NP-11-0021
June 2, 2011

Subject: Exelon Nuclear Texas Holdings, LLC
Victoria County Station Early Site Permit Application
Response to Request for Additional Information Letter No. 08
NRC Docket No. 52-042

Attached are responses to NRC staff questions included in Request for Additional Information (RAI) Letter No. 08, dated April 19, 2011, related to Early Site Permit Application (ESPA), Part 2, Sections 02.03.02, 02.04.03, 02.04.12, and 02.04.13. NRC RAI Letter No. 08 contained fourteen (14) Questions. This submittal comprises a partial response to RAI Letter No. 08, and includes responses to the following two (2) Questions:

Figure 2.4.12-26a Plan View Showing Locations of Orthogonal Cross Sections

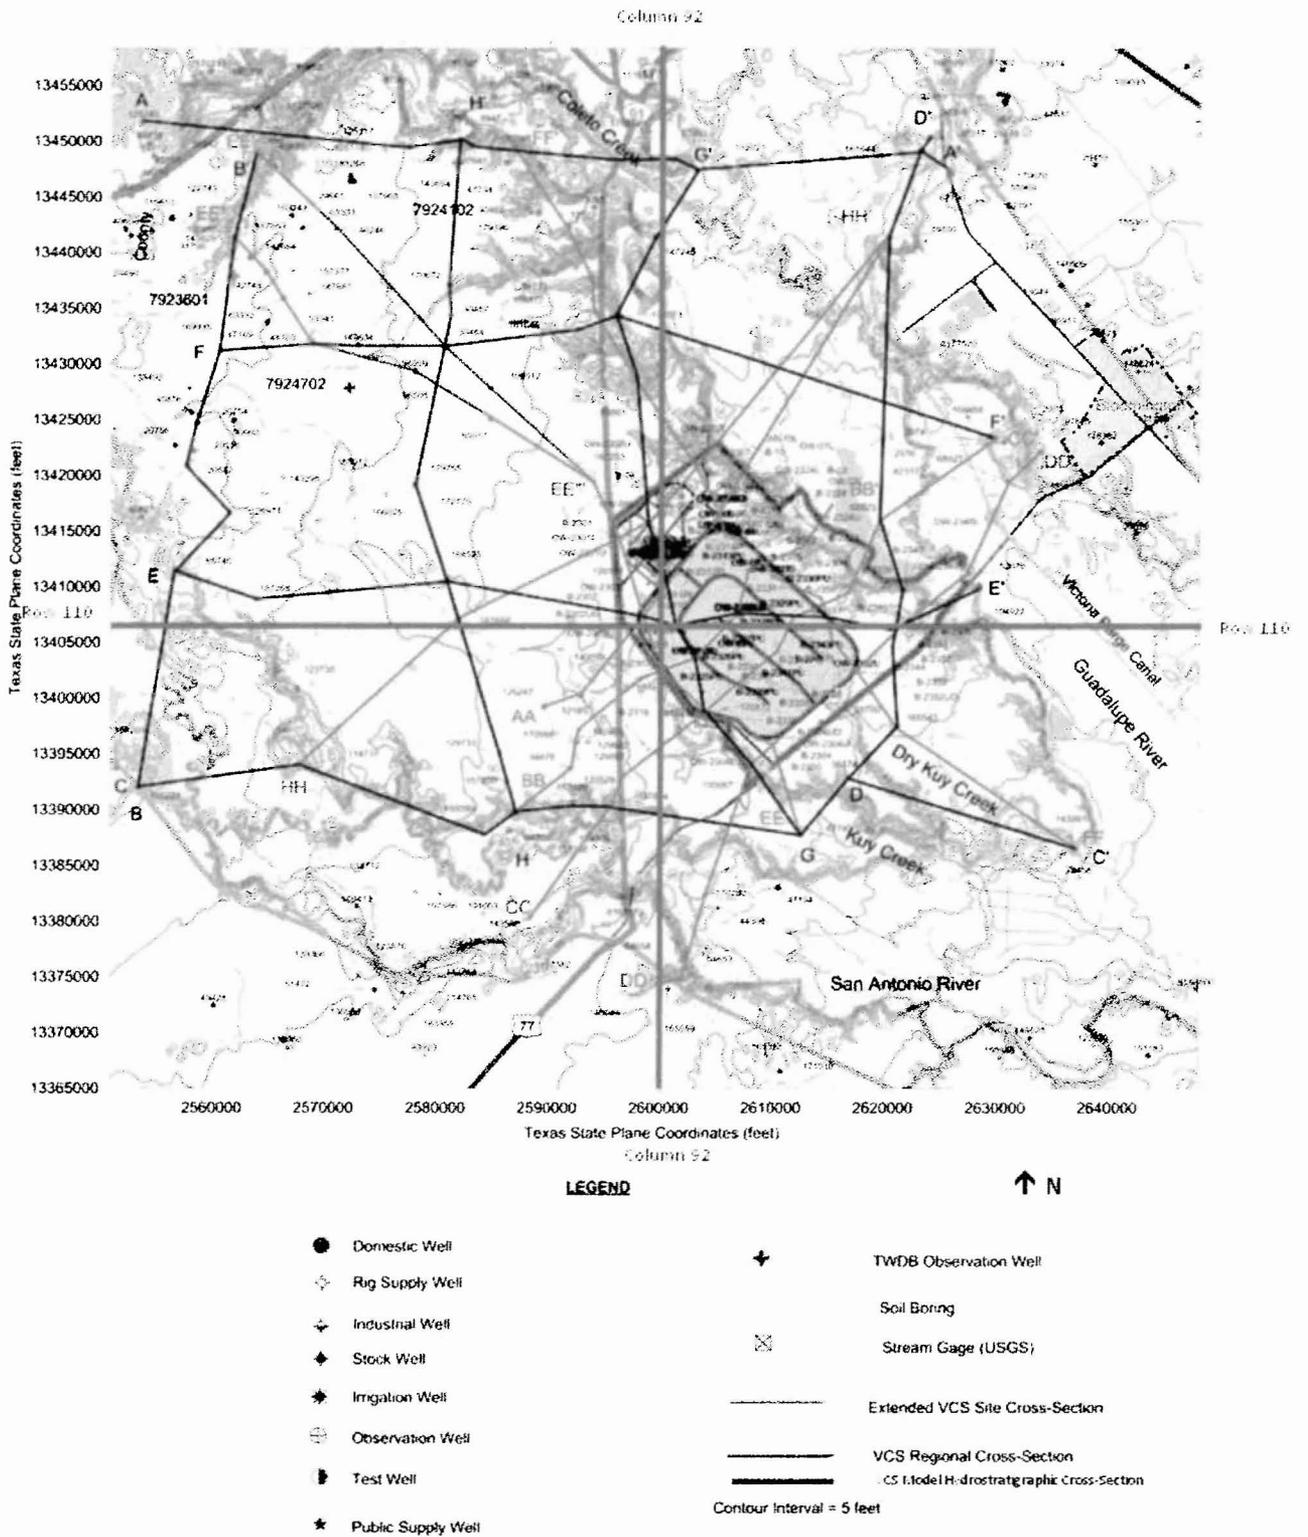
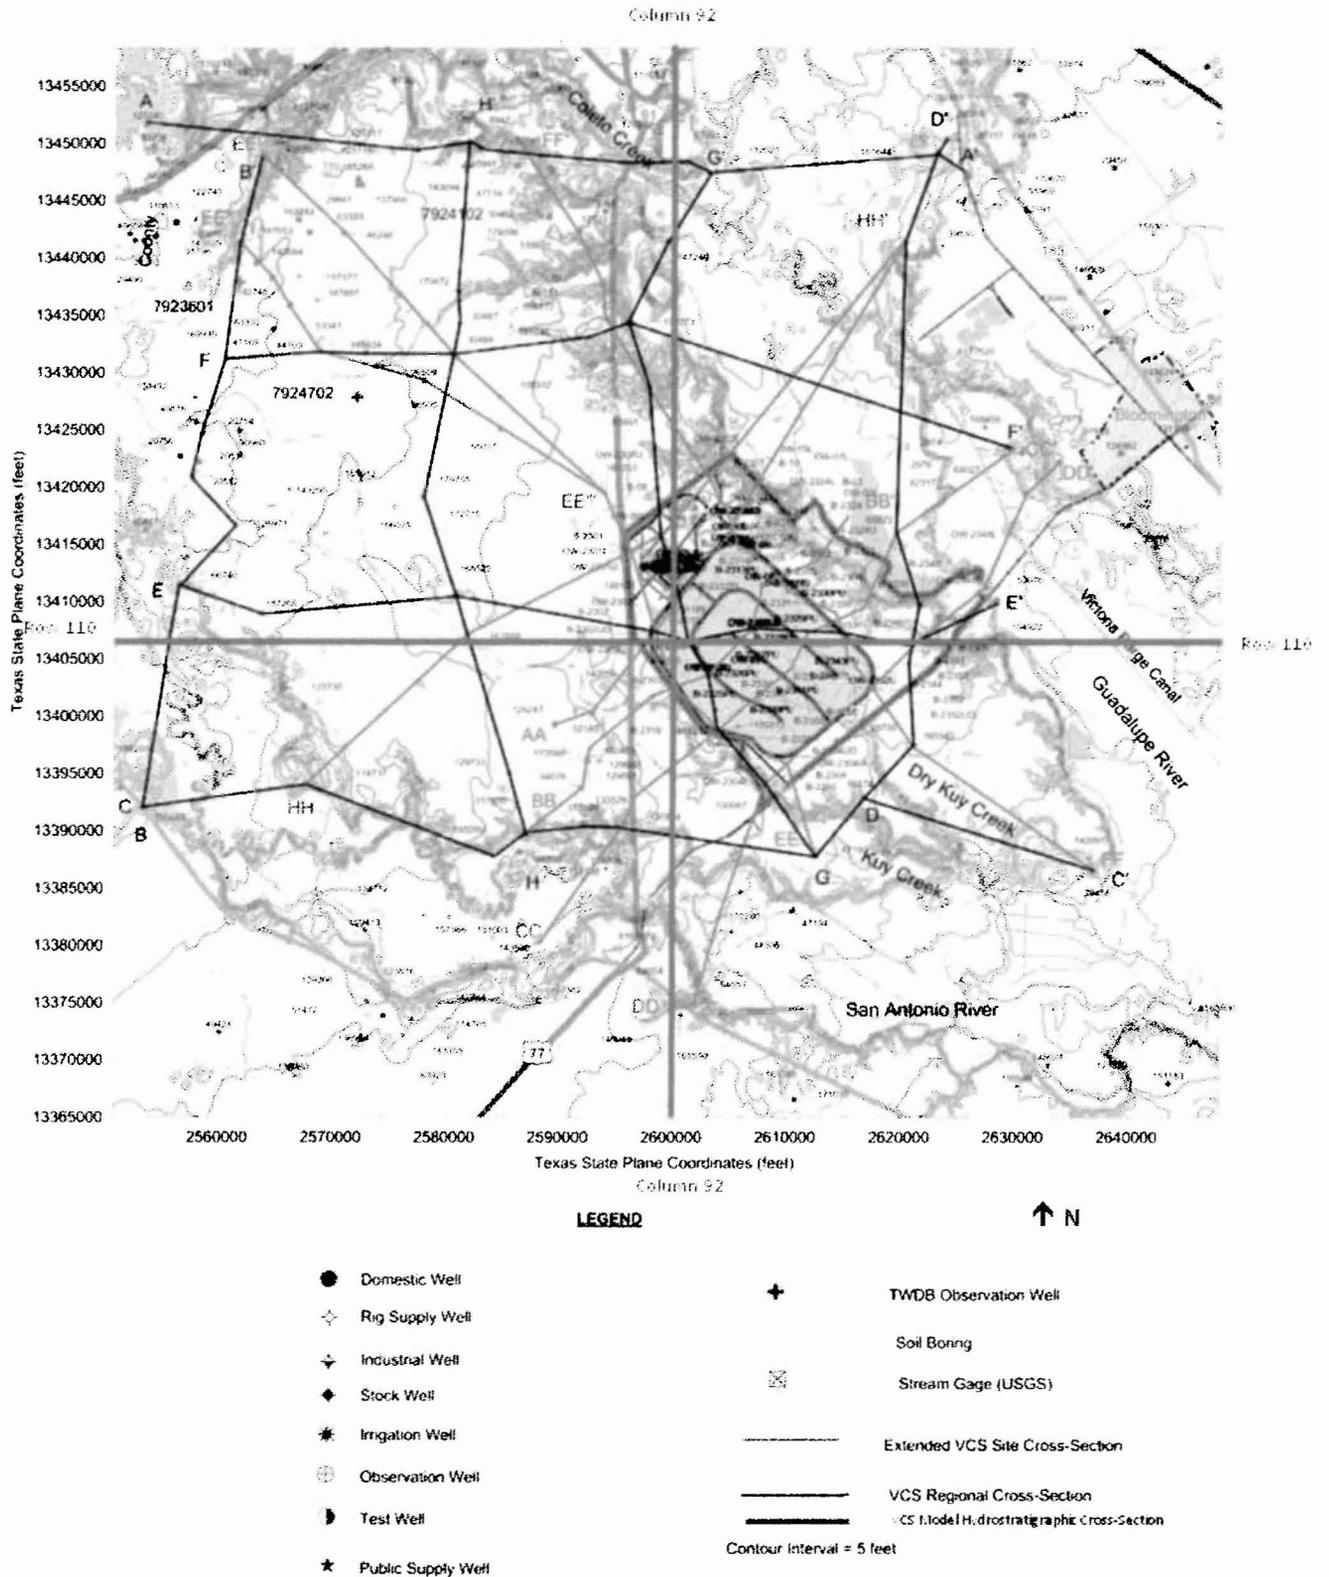
In accordance with the requirements of 10 CFR 100.20(c) "Factors to be considered when evaluating sites" relating to hydrology and, 10 CFR 52.79(a) "Contents of applications; technical information in final safety analysis report" relating to hydrologic characteristics of the proposed site, and as recommended by Standard Review Plans 2.4.12 "Groundwater" acceptance criteria, the NRC Staff requests that the Applicant provide: (1) Two orthogonal cross-sections across the site with the hydro-lithologic units labeled consistent with site nomenclature and include the vertical direction of ground water flow and the potentiometric surfaces for the hydrologic layers; and (2) Two orthogonal cross sections (replacing or adding to FSAR, Rev0, Figure 2.4.12-26), of the model grid that approximate the location of the two hydro-stratigraphic cross-sections in (1) above.

The locations of the cross sections are shown in Figure 2.4.12-26a.

As stated in Subsection 2.4.12.3.1.2.1, hydrogeologic cross-sections and structure contour maps were developed from the subsurface data obtained from the VCS site subsurface investigation and from regional driller's log databases. These cross-sections and contour maps were used as the basis for the hydrogeologic layers developed for the numerical groundwater model. The locations of the cross-sections are shown in Figure 2.4.12-26a. Figures 2.4.12-26b and 2.4.12-26c present orthogonal hydrogeologic cross-sections E-E' and G-G'.

Figure 2.4.12-31 Hydrogeologic Cross-Section BB-BB'

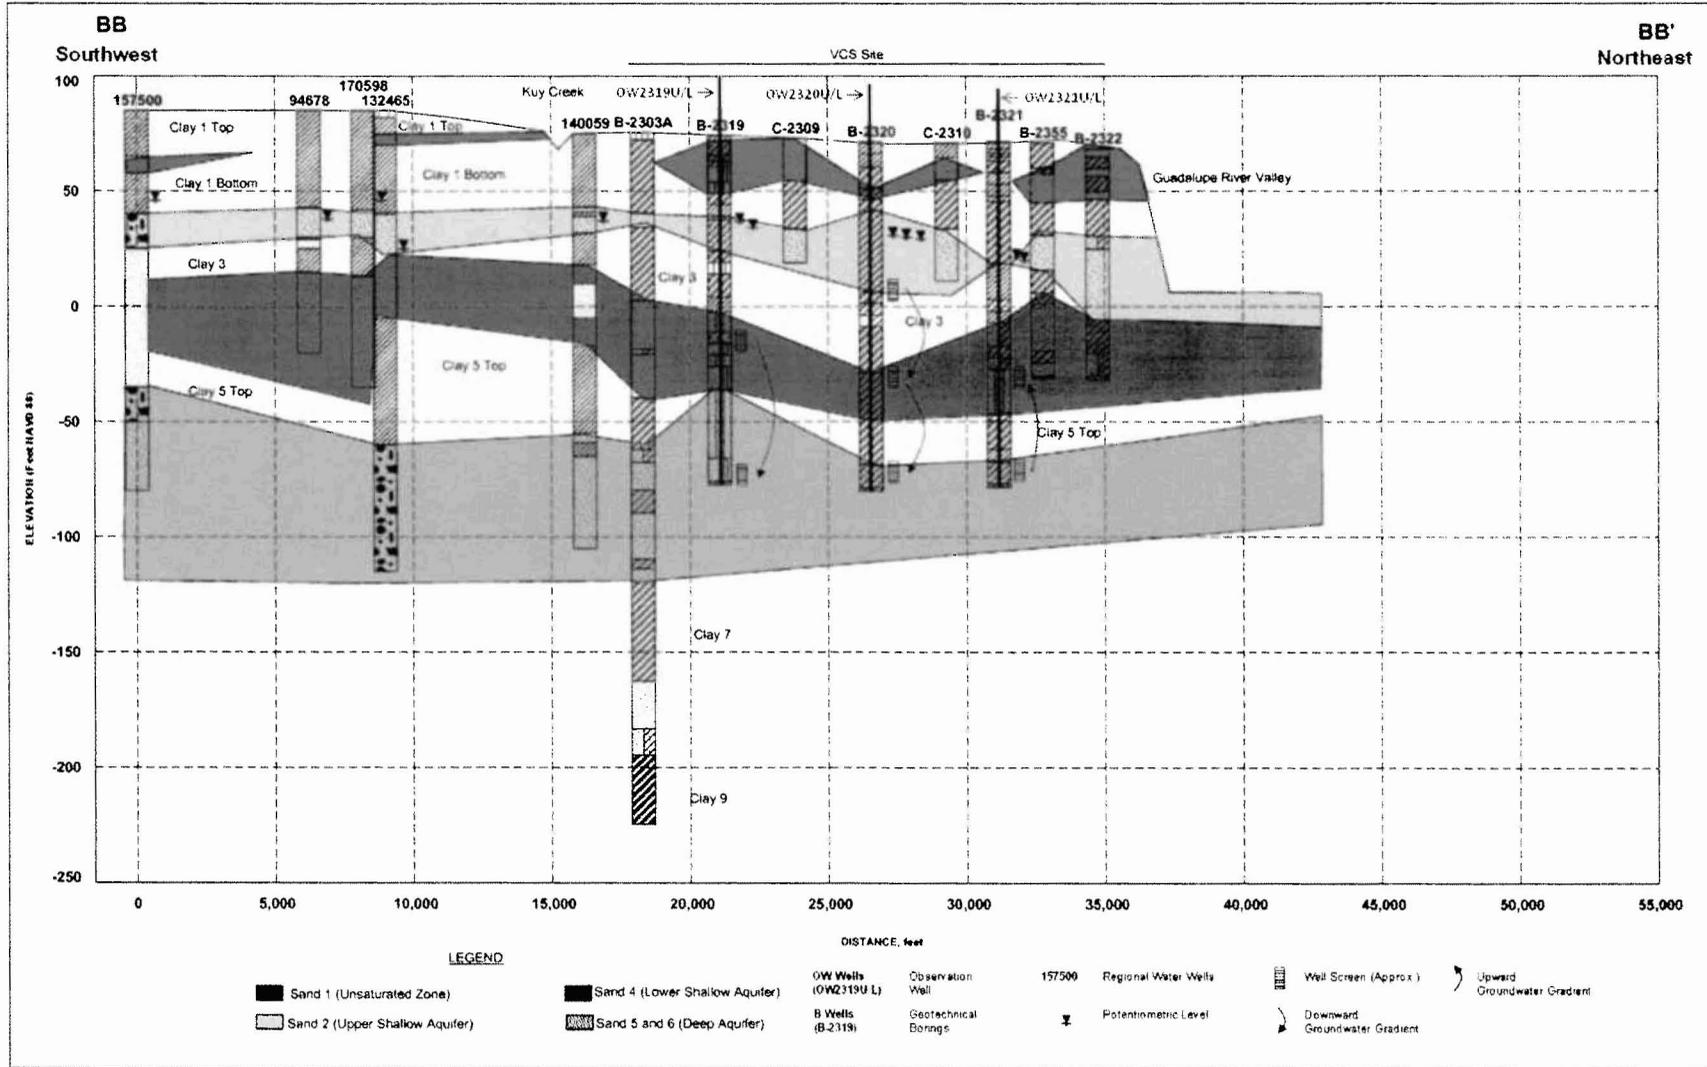
In accordance with the requirements of 10 CFR 100.20(c) "Factors to be considered when evaluating sites" relating to hydrology and, 10 CFR 52.79(a) "Contents of applications; technical information in final safety analysis report" relating to hydrologic characteristics of the proposed site, and as recommended by Standard Review Plan 2.4.12 "Groundwater" acceptance criteria, the NRC Staff requests that the Applicant provide: (1) A detailed description of how various site specific hydro-lithologic units were defined, particularly the distinction between the upper shallow and lower shallow aquifer units subdividing the Chicot aquifer; and (2) A discussion of the importance or influence of holes in confining units beneath the footprint of the site and cooling basin on vertical groundwater gradients and movement during post-construction.

The response to RAI 2.4.12-5 provides two hydrogeologic cross-sections: BB-BB' and HH-HH' (SSAR Figures 2.4.12-31 and 2.4.12-32, respectively). These hydrogeologic cross-sections demonstrate that the various sand units at the site form discrete aquifer zones with contrasting potentiometric levels and provide justification for subdivision of the Chicot aquifer at the VCS site. The response to RAI 2.4.12-6 provides two additional hydrogeologic cross-sections: E-E' and G-G' (SSAR Figures 2.4.12-26b and 2.4.12-26c, respectively).

Cross-sections BB-BB' and G-G' both show the stratigraphy at soil boring B-2319 (where the cross sections cross each other) but with slightly different interpretations because of differing perspective due to different orientations of the cross-sections. The stratigraphic interpretation in BB-BB' is incorporated in the layering of the VCS numerical model because it provides better characterization of layering within the Deep aquifer, based on soil boring information. No significant differences in the stratigraphic interpretations appear on the other cross sections, where they cross each other.

Figure 2.4.12-17 contains several hydrographs, each showing a time series of the potentiometric heads in an observation well pair, including those well pairs shown on cross-sections BB-BB' and HH-HH'. The hydrographs demonstrate a generally consistent vertical potentiometric gradient between the upper and lower screen zones in each well pair. The difference in potentiometric head between the sand strata in Figures 2.4.12-31 and 2.4.12-32 in which the well screens are completed provides evidence that the sands are to some extent hydraulically isolated from each other by the intervening strata comprised predominantly of silt and clay. These finer-grained strata are interpreted to be confining layers acting as aquitards, while the sand strata are interpreted to be aquifers.
